Keithley Instruments, Inc.
28775 Aurora Road
Cleveland, Ohio 44139-1891
1-888-KEITHLEY
www.keithley.com

Version v1.6.3d Release

Version 1.6.3d is an audited minor release which fixes a number of different bugs all listed below.
[RELEASED 18-APR-2017](#)

GENERAL Models affected:

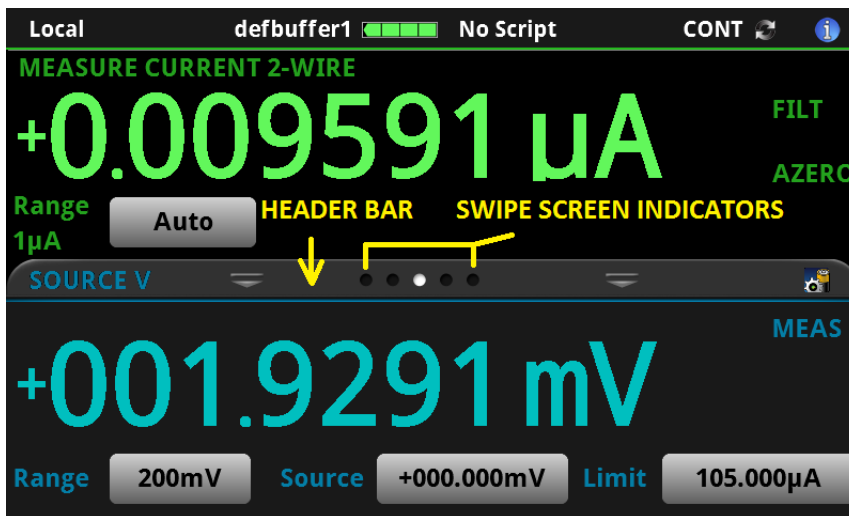
A number of improvements have been made to the overall Graphical User Interface as follows:

1. Screen Colors: All screen colors have been modified for better contrast and easier readability.
2. Pinch-to-Zoom Performance: Throughout the user interface, the “Pinch-to-zoom” touch screen motion has been improved and is more responsive.

3. Improve Swiping:
 - a. The swipe user interface gesturing has been dramatically improved and is more responsive.
 - b. Added Vertical Swiping in various screens in the GUI.

- c. Horizontal swiping has been made more smooth and is consistent with Vertical Swiping.
 - d. “Fling” swiping has been implemented where faster swiping actions result in rapid scrolling followed by decay based on the velocity of the “fling.”

- e. Swipe Down on the Home screen will display larger readings.
4. Tabs and Buttons: Throughout the user interface multiple data display options have been made available through tabs (header bars) with swipe screen indicators to show how many different display options are available and which display tab is active.

5. Graphing:
 - a. New Auto Scale Options (X-Axis) → Track Latest, Track Group
 - b. New Auto Scale Options (Y-Axis) → y-swim lanes, y-shared, y-per trace
 - c. Multi-Trace Line Plots
 - d. Multi-Trace Scatter Plots
 - e. Various refresh and performance improvements

6. Histogram:
 - a. New Auto-Scale, Auto-Bin, and Fit
 - b. Smartscale choose best scaling option
 - c. Various refresh and performance improvements
7. TTI Synchronization: All Touch, Test, Invent® Keithley Models including the 2450, 2460, and 7510 have been carefully updated so that they are all consistent in look, feel, and general navigation.
8. Updated Reading Table: Added new reading table features and a new Reading Preview Graph. Please see the Reference Manual for further details.
